Development Review Division

SUBJECT: SP21-063; Douglas 234 F6 L1 – Gas and Convenience Store
SP21-064; Douglas 234 F6 L2 - Car Wash
Review Comments 03

LANDSCAPE PLAN

L1.1

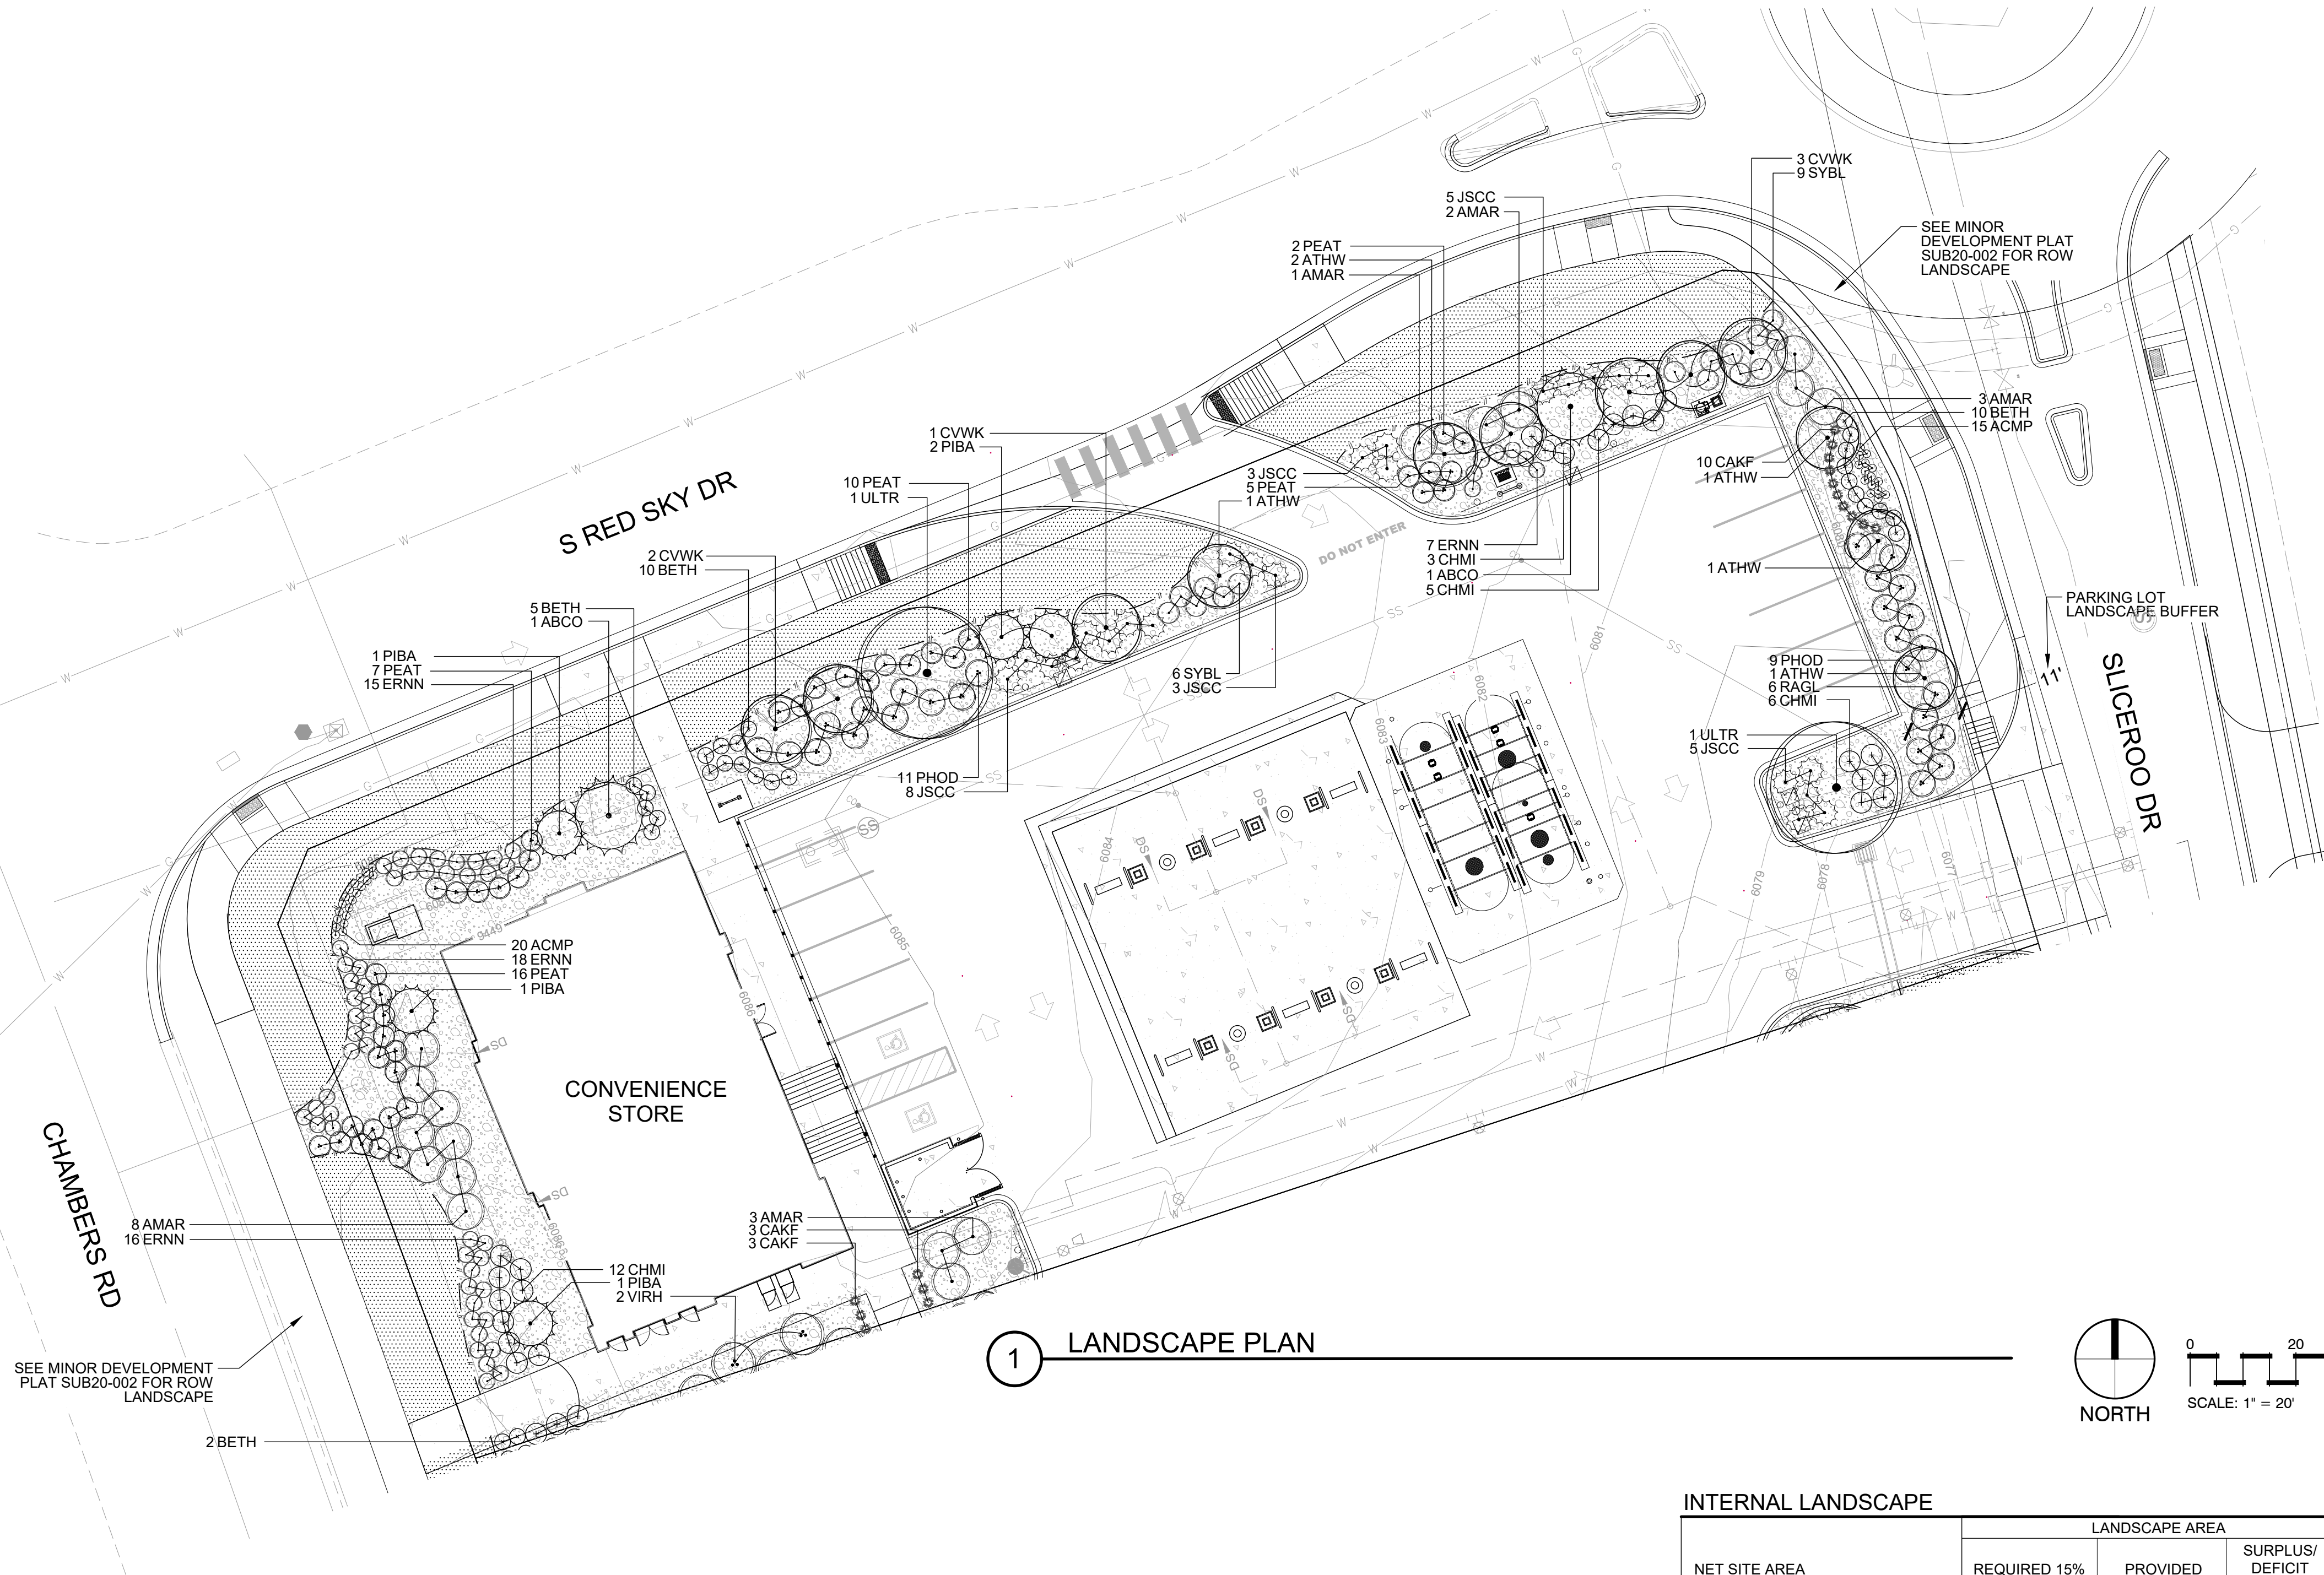
REQUIRED	PROVIDED	PLANT REQUIREMENT NOTES: 1. ORNAMENTAL GRASSES AND PERENNIALS ARE COUNTED TOWARD TE'S AS 3 GRASSES = 1 SHRUB. When added up, all of your shrubs in this column total 249. When I look at your plant schedule you have 233 shrubs and 16 grasses. Grasses can only be used to replace shrubs and not shrubs that are replacing trees. Also, if you are replacing shrubs with grasses its 3:1 so you would need to have 48 grasses, not 16 (you are replacing on one to one which is not allowed. You would also need to show the grass to shrub replacement in your chart. But again, these grasses cannot replace shrubs which replace trees.
TOTAL TREES/TE'S	33	33

These numbers included grasses and perennials (at a 3:1 ratio). Shrub numbers and grasses have now been separated. Grasses are substituting for shrub requirements only, which has been noted.

1 LANDSCAPE PLAN

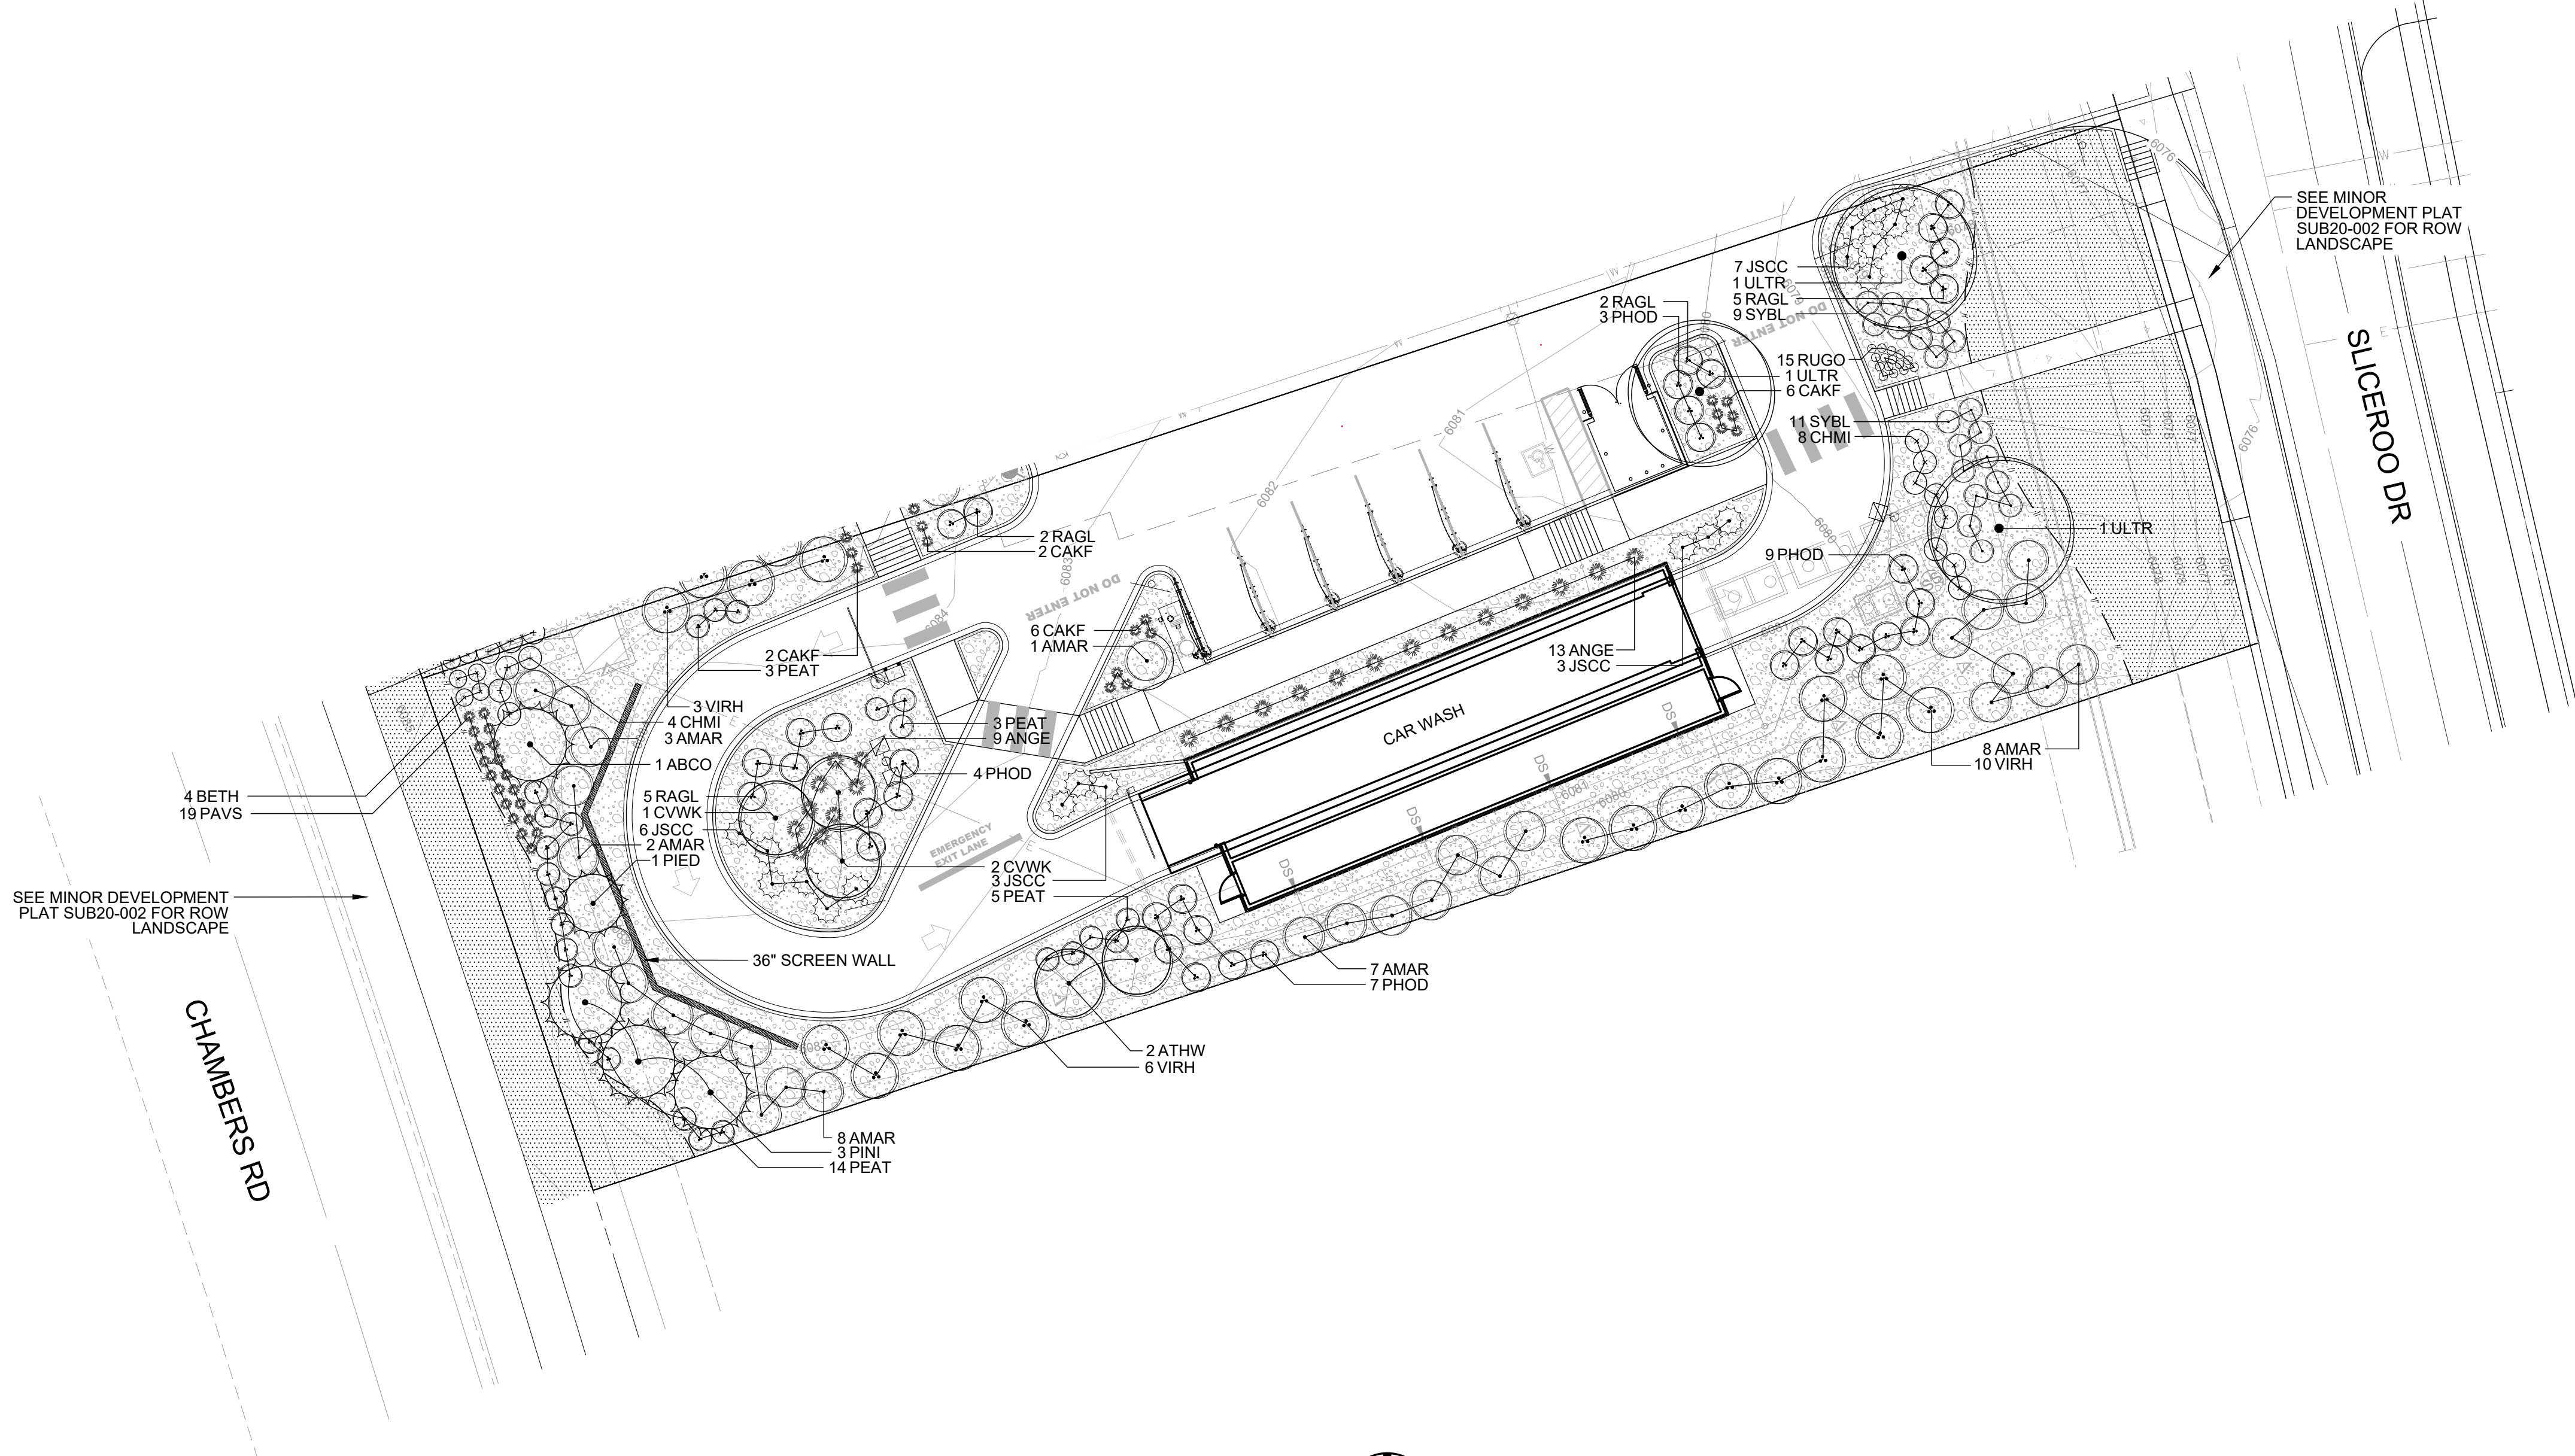
unless you are adding 3 addition TE from the shrubs which should then be shown

This should be 3 unless you are adding 3 addition TE from the shrubs which should then be shown

This should also state 34

This should be zero-there are no tree equivalents

Needs to say Trees/TE's

Need to include required and provided shrubs total

When added up, all of your shrubs in this column total 189. When I look at your plant schedule you have 165 shrubs. Grasses can only be used to replace shrubs and not shrubs that are replacing trees. Also, if you are replacing shrubs with grasses its 3:1. You would also need to show the grass to shrub replacement in your chart. But again, these grasses cannot replace shrubs which replace trees.

Revised

Revised

Revised

These numbers included grasses and perennials (at a 3:1 ratio). Shrub numbers and grasses have now been separated. Grasses are substituting for shrub requirements only, which has been noted.

Revised

1 Shrub and grass totals have been added
